TO: T10 Membership
FROM: Paul A. Suhler, Quantum Corporation
DATE: 21 February 2006
SUBJECT: T10/06-061r0, ADC-2 Model for Devices with No ADT Ports

06-061 Revision 0

Figure n

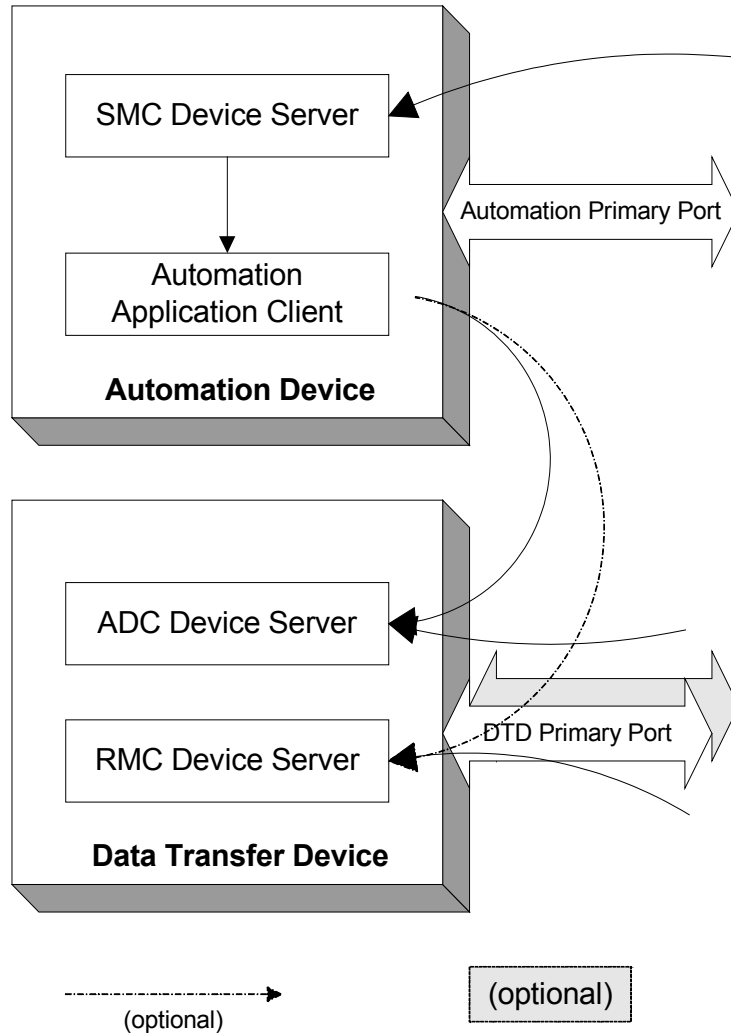
Figure n shows an automation device and a DT device similar to those in Figure 3, but without any ADT or alternate ports. The application clients and device servers communicate via the primary ports, with at least one automation primary port being a SCSI target/initiator port. If enabled (see 6.2.2.4.2), the RMC device server shall be accessible as a logical unit through the DT device primary port. The ADC device server shall be accessible as a logical unit through the DT device primary port. There is no need for a local SMC device server, because the SMC device server is directly accessible via the automation device's primary port.

Add following Figure 3:
